MILITARY SPECIFICATION

BOYD HELICOPTER RESCUE SEAT

This amendment forms part of Military Specification MIL-B-21902A(Wep), 17 April 1963, and has been approved by the Bureau of Naval Weapons, Department of the Navy.

Page 8, Figure 5.

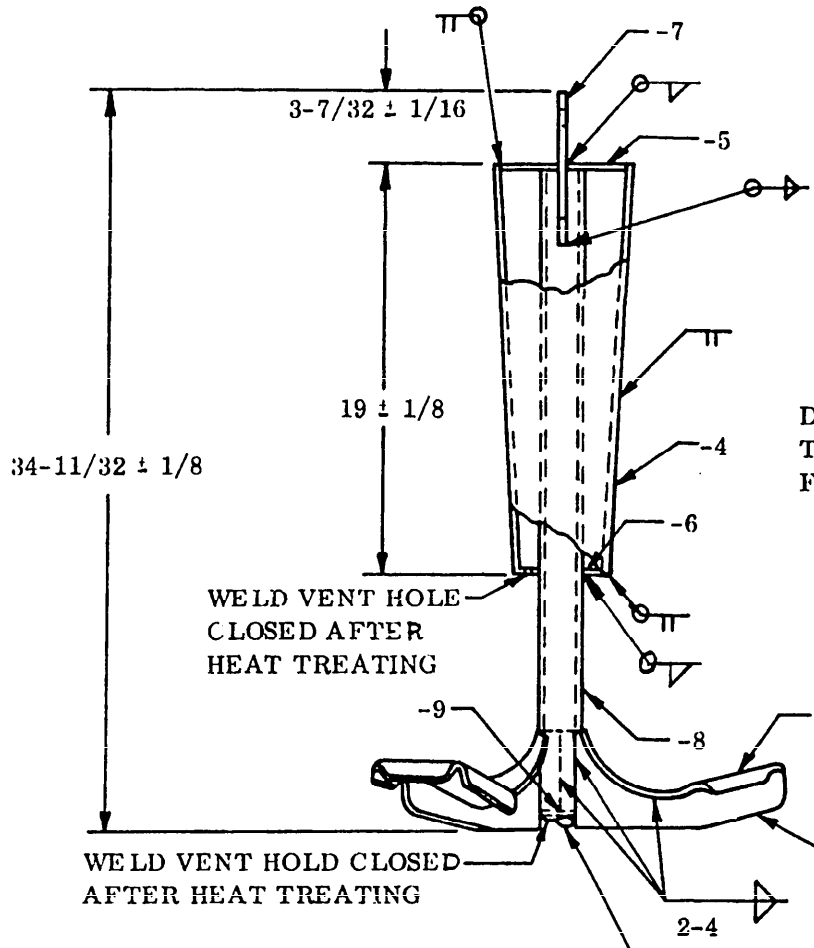
(a) Under "-8 TUBE MATERIAL:", delete "WW-T-789, TYPE I, TEMPER O.", and substitute "WW-T-700/6".

(b) Under "-9 CAP MATERIAL:", delete "QQ-A-327, TEMPER O", and substitute "QQ-A-250/11".

FIGURE 2. -1 SEAT ASSEMBLY

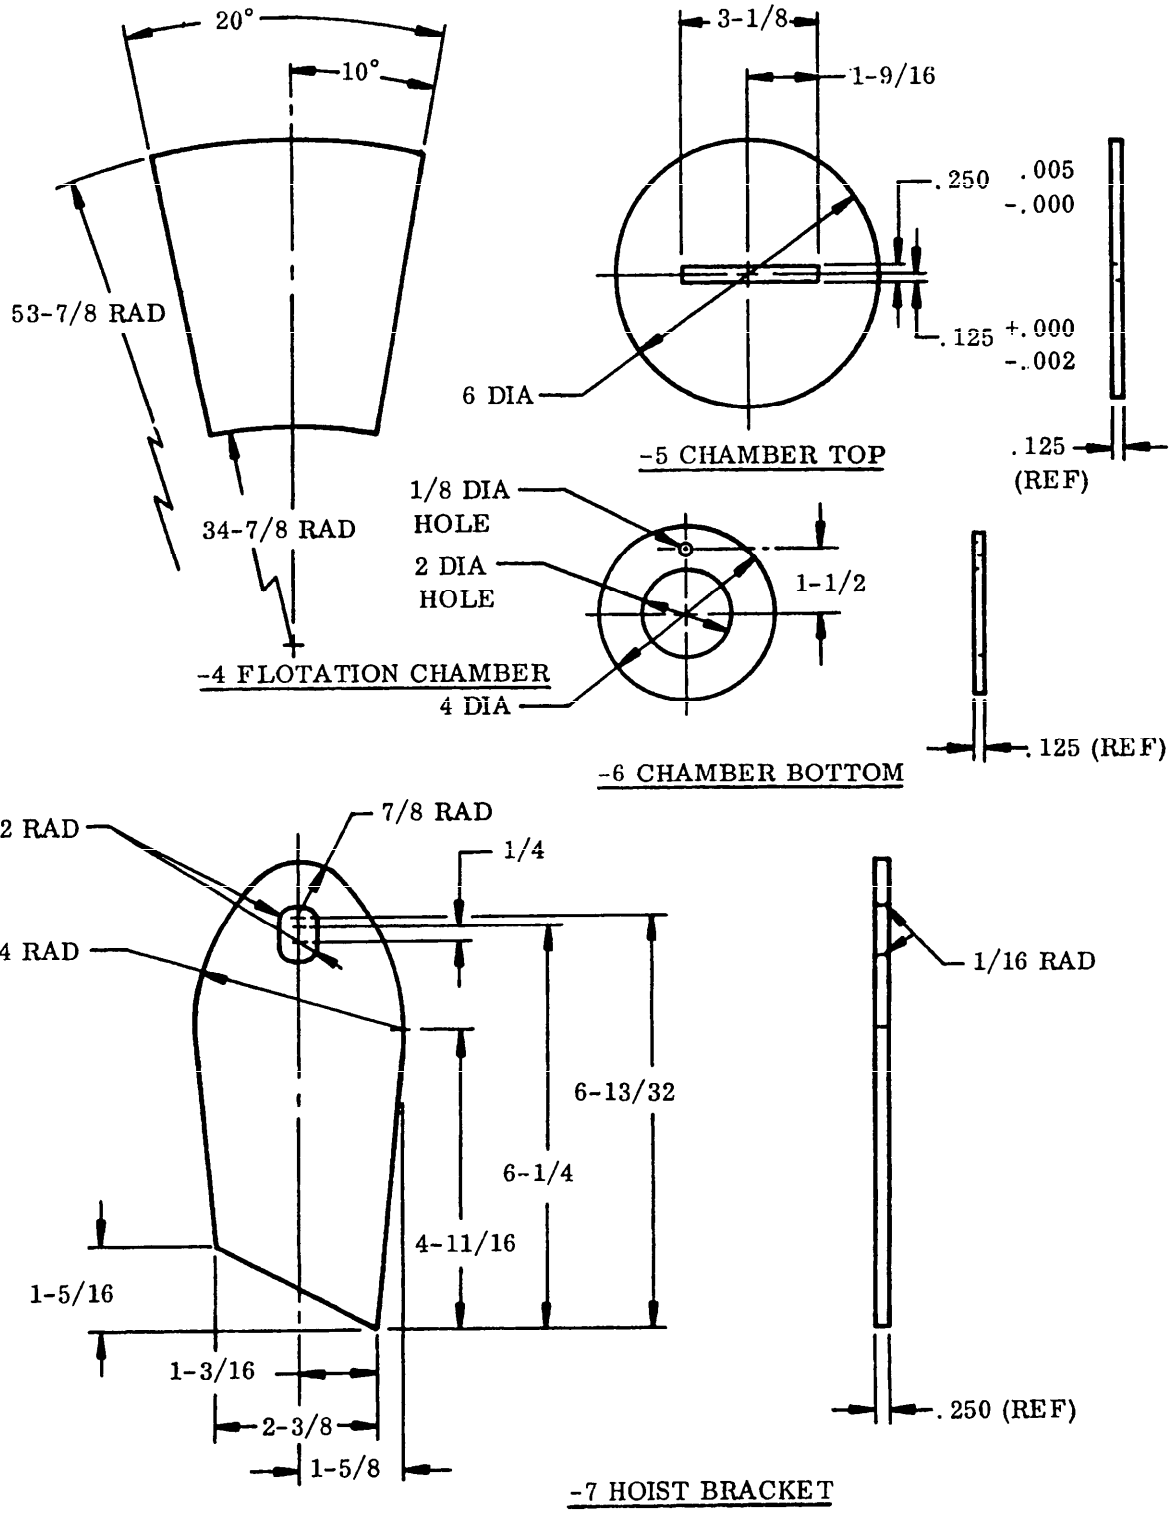
Page 5, Figure 2. Delete and substitute new "Figure 2" attached.
